Evidence ET-5:

Evidence regarding “Masterplan creep” and its Impacts

LAND AT ELMSBROOK, BICESTER: PROPOSED RESIDENTIAL DEVELOPMENT

Planning Inspectorate Ref.No. APP/C3105/W/23/3315849

Figure 1: CDC Published NW Bicester Masterplan diagram showing Proposed Primary Roads etc.

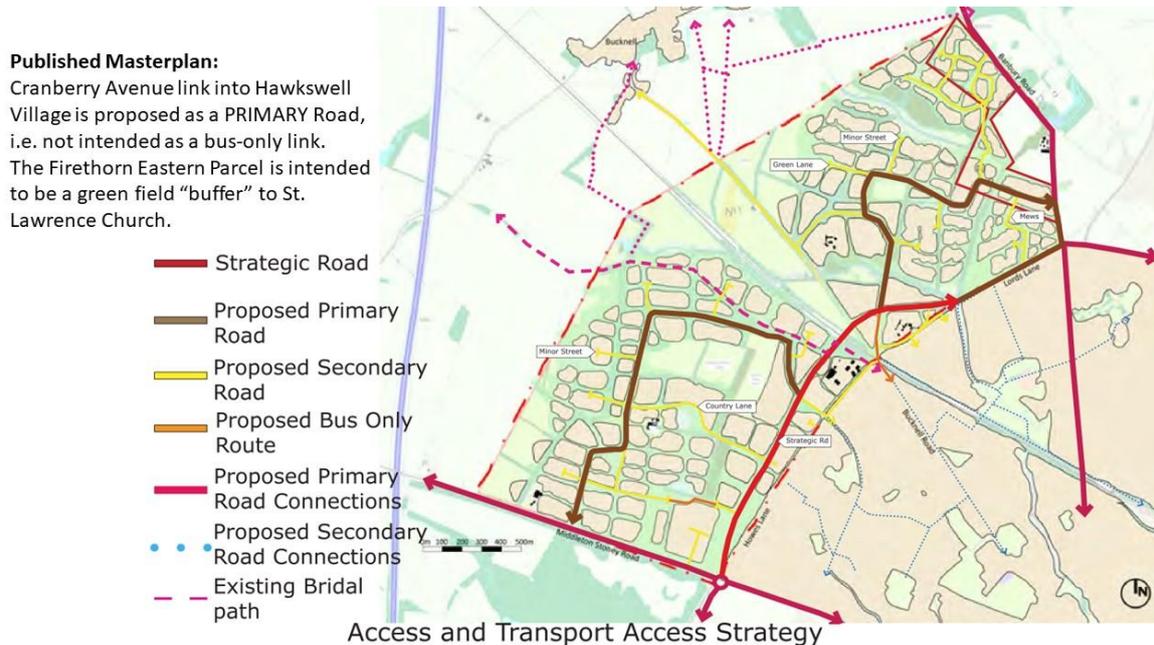
- 1.1 Figure 1 shows clearly that the NW Bicester Ecotown Masterplan’s Primary Road design includes one such route going via Cranberry Avenue from the south west into Elmsbrook Phase 2, then along Charlotte Avenue east. (NB: Although the version of the plan shown in Figure 1 is from 2014, which is the published release version currently on the CDC Website for the Ecotown Masterplan, this routing design did not change in later minor updates for the published NW Bicester SPD in February 2016).

- 1.3 OCC Highways responded to ETPG by suggesting that, yes the traffic levels might be a large proportion higher, but that this could be simply mitigated by inserting a planning condition to make the Cranberry Avenue – Charlotte Avenue junction into a “bus gate” allowing bus, cycle and pedestrian access only, and not allow cars/vans through. The OCC highways suggestion does not demonstrate evidence, i.e. by presentation of any form of data, that doing so *would actually be enough* to make traffic levels low enough. ETPG pointed out that this goes against the Published Masterplan, which shows this to be a Primary Road route.

- 1.5 Adding such a condition to another proposal which has yet to reach committee for Outline planning (1) goes against the Masterplan design; (2) could be showing favouritism to one phase developer over another; (3) changes Masterplan parameters without review.

Figure 3: Published NW Bicester SPD (2016) Masterplan drawing, showing the Eastern Parcel now *within* the Ecotown boundaries, and having only a small area only (labelled ‘A’) for housing. The much greater area (labelled ‘B’) provides the green ‘buffer’ as required by NWBSPD paragraph 5.28.

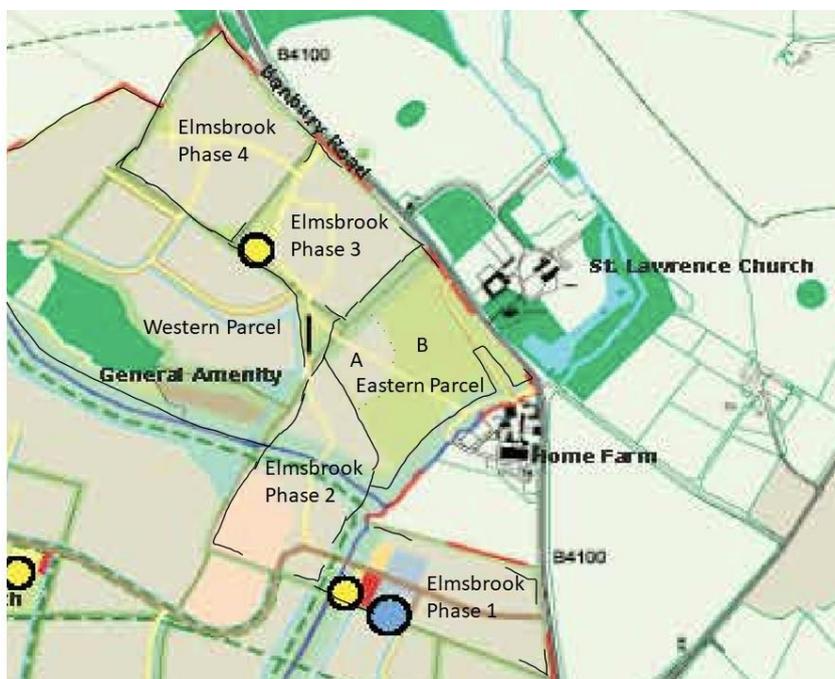
- 2.4 Figure 3 shows that, despite the above being true up to 2014-15, the final version which was published in the NW Bicester SPD in February 2016 includes in illustrations a *small area* of housing as well as the much larger green 'buffer' – these are shown as the areas labelled 'A' and 'B', respectively, on Figure 3. Based on the 'illustrative' area shown, it is suggested that perhaps 50 homes would fit in that area.

- 2.5 When the first proposal for development of the Eastern Parcel (only) was produced, this increased the size of the housing area along with the number of homes – to 75, however, there was still a reasonable green 'buffer' to both St. Lawrence's Church and Home Farm. That application was then withdrawn. When the Appellant's application began, the number of homes increased again, this time to 120 homes located on this field, and with barely any green border now remaining.

- 2.6 St. Lawrence's Church and Home Farm both had entirely reasonable expectations that such a "gradual creep" (from 0 to 50 to 75 to 120 homes) on the land earmarked as their green 'buffer' zone would not be allowed; or at least, would be limited to a sensible number or a sensible area, as required to maintain the agreed adequate 'buffer' (as per NWNSPD 5.28).

It is clear that, even though the SPD (Feb. 2016) changes the Masterplan to allow *some* housing on this field, it is a *tiny area* – with the ‘buffer’ originally promised being largely kept, for Church and Farm.

- 3.1 Figure 3 also indicates the 'bus gate' between Elmsbrook Phases 2 and 3, and that the few homes proposed for the Eastern Parcel would connect to Phase 3 (Braeburn Avenue), and thus there would be no traffic from either Western or Eastern Parcels (of the proposed application) being accessed from the end of Charlotte Avenue.
